**Re: Freeport-McMoRan Tyrone Inc.,
Permit GR010RE Emma CCP Response Letter**

Freeport-McMoRan Tyrone Inc. (Tyrone) submitted an application for an expansion to the Tyrone Mine for the Emma Project on October 22, 2021 and Closure/Closeout Plan (CCP) on November 12, 2021. In a letter dated April 25, 2022, Mining and Minerals Division (MMD) provided comments. Tyrone appreciates the comments and the opportunity to respond.

Conceptual arrangement of light plants for first year of mining

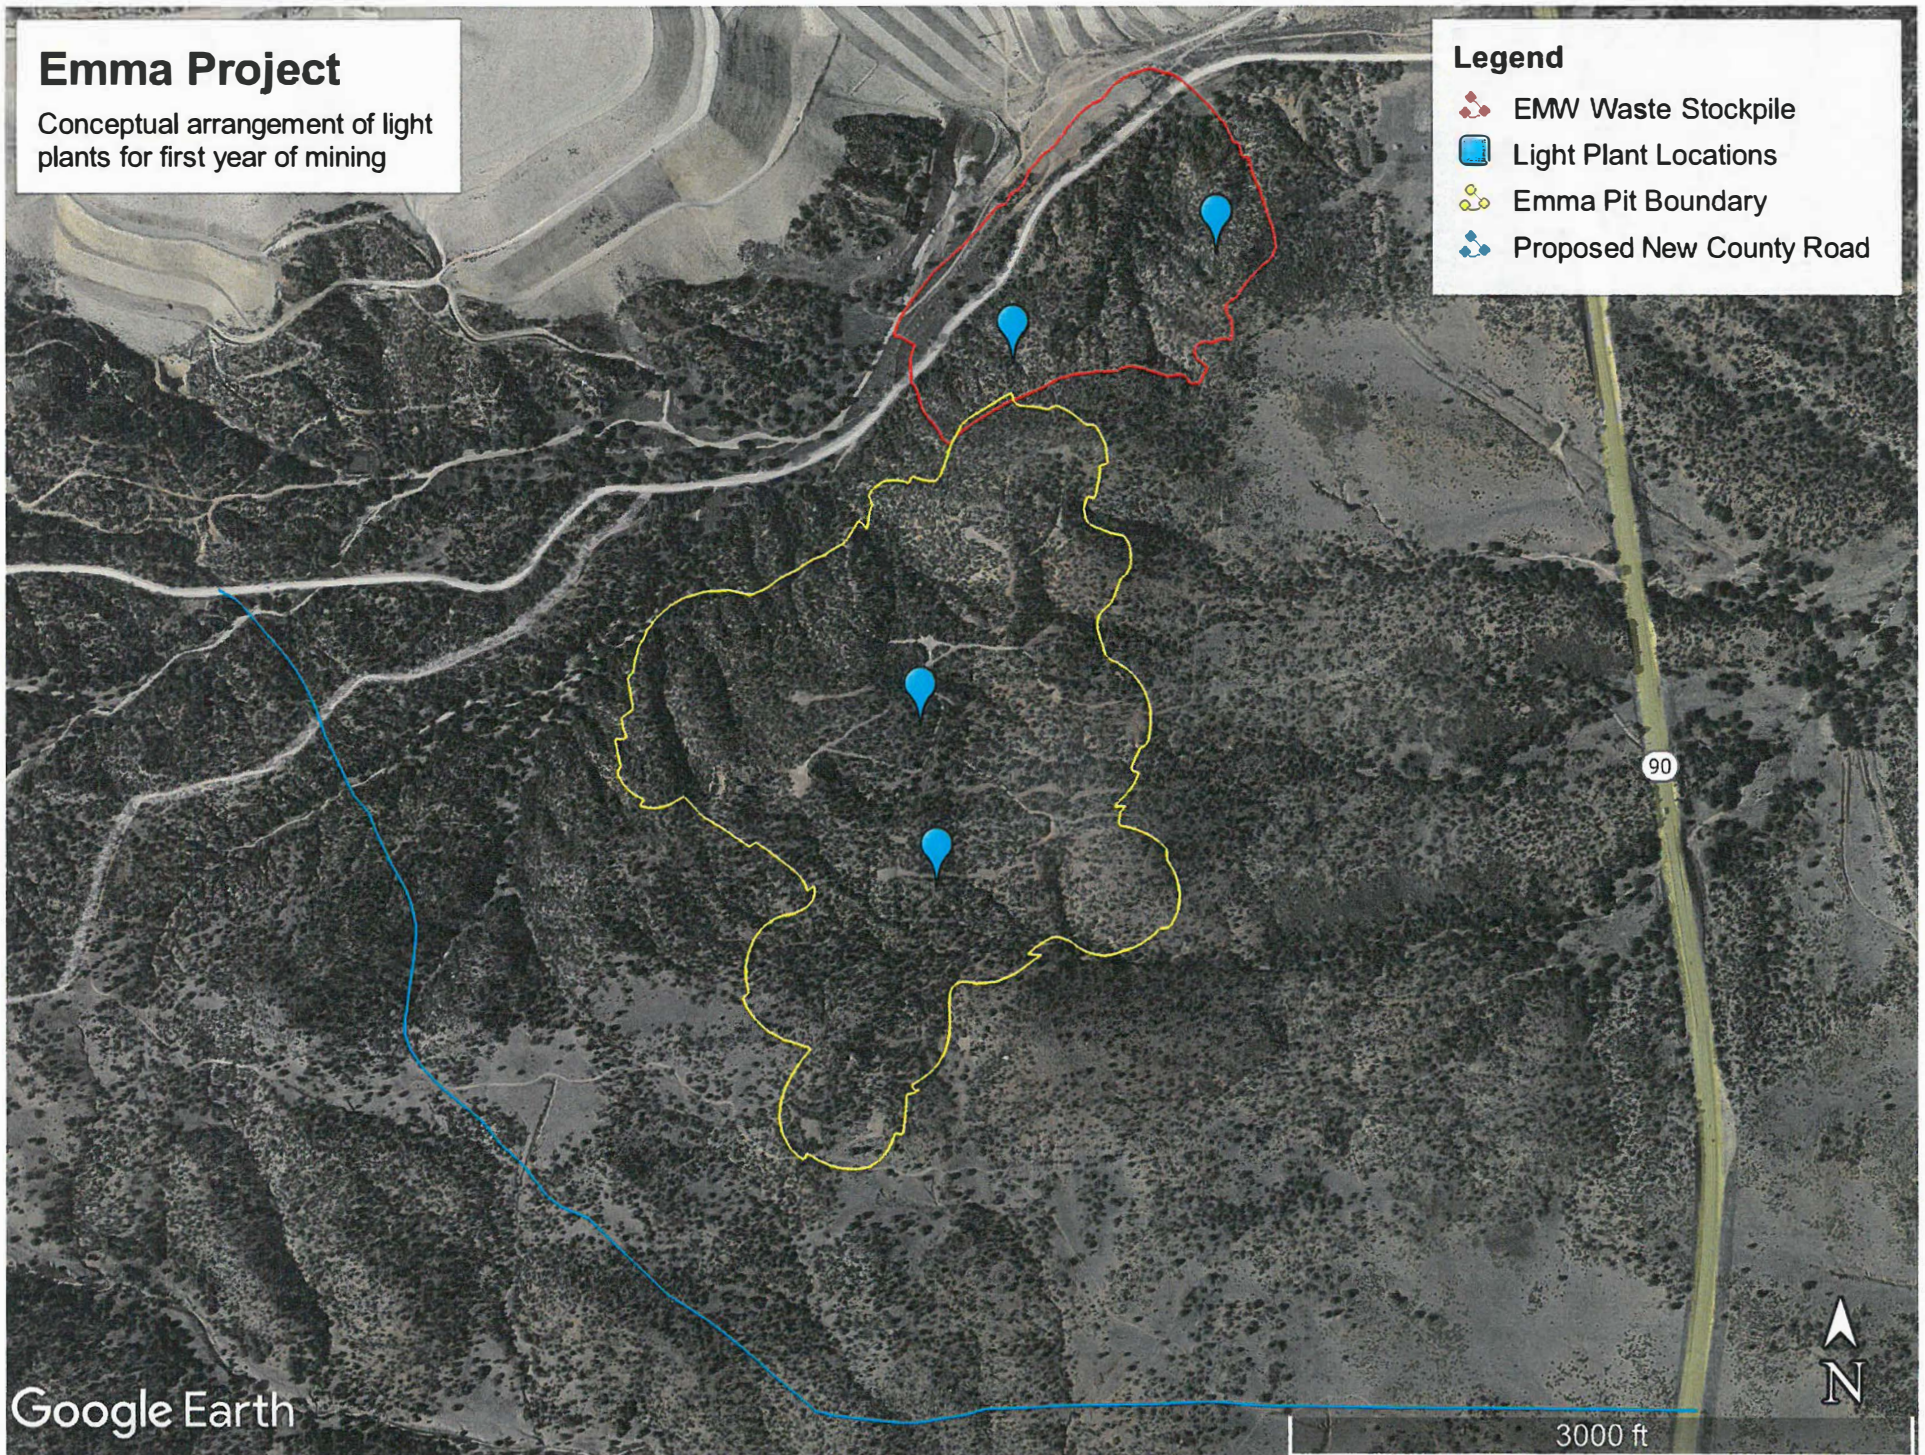
1. *Section 3.0, Project Impacts, page 5, states that considering that the closest residential receptor will be approximately a mile away from the Emma Project during initial phases of the project while at ground level, lighting will be visible at receptors located to the south of the project for less than one year. Please provide a conceptual arrangement for the lighting systems that will be used during the initial phases (during the first year) of the project on a drawing of the Emma Project area.*

During the first year, Tyrone will primarily be working day shift, approximately 6am to 6pm (haul road construction, soil salvaging, etc.). The use of nighttime lighting will be limited during the first year of mining, (ex. pit and stockpile development).

Attached is a figure showing the conceptual arrangement for the lighting systems that will be used during the initial phases (during the first year of mining) of the project. Please note that the lighting equipment will be mobile, and locations will change as mining and stockpile development progresses.

The EMW Waste stockpile will generally be developed from the bottom/toe up. As a result, most of the light sources from EMW Waste stockpile will not be visible to the residents located south of Emma project during the first year of mining (there is a ridge to the south of the stockpile blocking their initial views).
